SUBJECT: DAIRYLAND POWER COOPERATIVE
LA CROSSE BOILING WATER REACTOR (LACBWR)
PROVISIONAL OPERATING LICENSE NO. DPR-45
RESPONSE TO QUESTIONS RELATIVE TO VOIDS
UNDER TURBINE BUILDING MAT

ENCLOSURE 1

BORING LOCATIONS

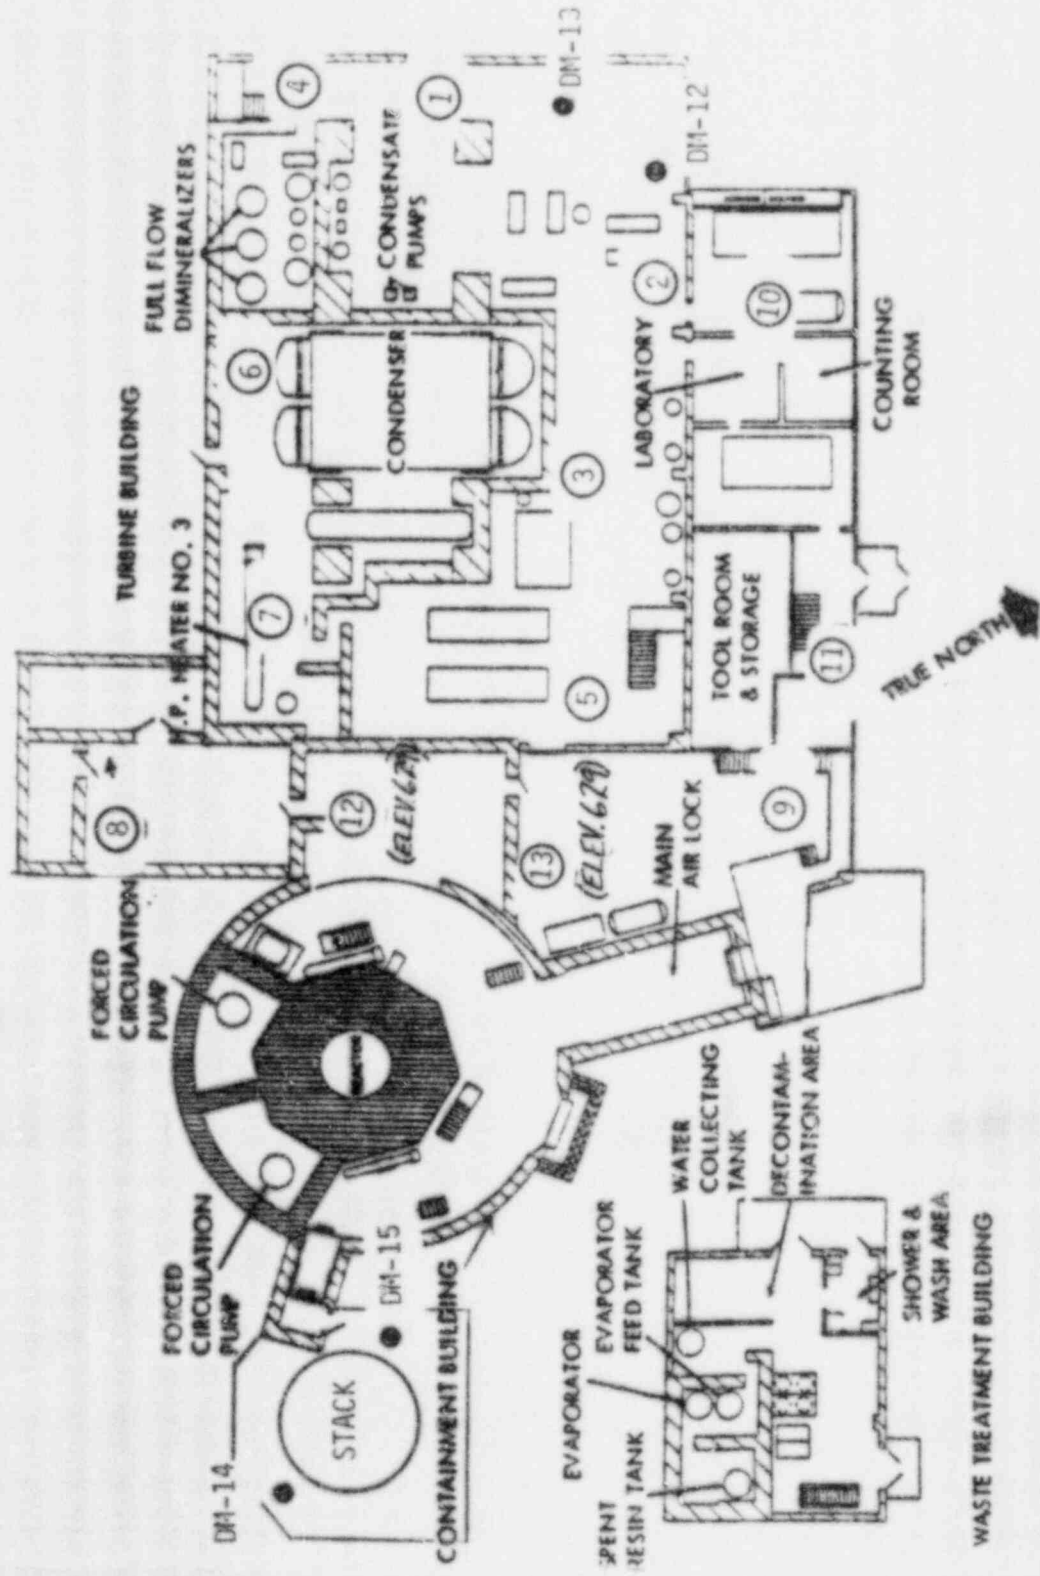
1. Description of Geometry of Voids Under Turbine Building:

During the recent test boring program within the developed area of the LACBWR plant site, two borings, DM-12 and DM-13, indicated the existence of minor voids in the vicinity of the borings. The other two borings, namely DM-14 and DM-15, drilled on either side of the stack did not indicate any such voids under its pile cap. The discovery of two minor voids raised the question whether voids exist beneath the turbine floor in other areas. In order to study the lateral and vertical extent of the voids, an exploratory drilling program was undertaken. DPC personnel drilled a total of 13 holes through the concrete floor using a light portable core drill. The locations of these bore holes 1 through 13 along with the recent soil borings DM-12, 13, 14 and 15 are shown in Plate 1.

Table 1 shows details such as the diameter of the holes, depth of concrete cored, and the approximate measured depth of voids below the concrete floor. It can be seen that the void depth ranges between 0 to 10 inches. The data also indicates that the voids exist only within the turbine building area. Lateral definition of voids could not be obtained due to varying floor thicknesses and the existence of the concrete beams under the floor.

We believe that by grouting the voids under the turbine building floor, any potential problems under seismic conditions will be solved. We are currently studying the most effective procedures that can be used to accomplish the above goal of filling all the voids under the turbine building floor with a suitable grout. We will submit the details of our proposed grouting plan in the near future.
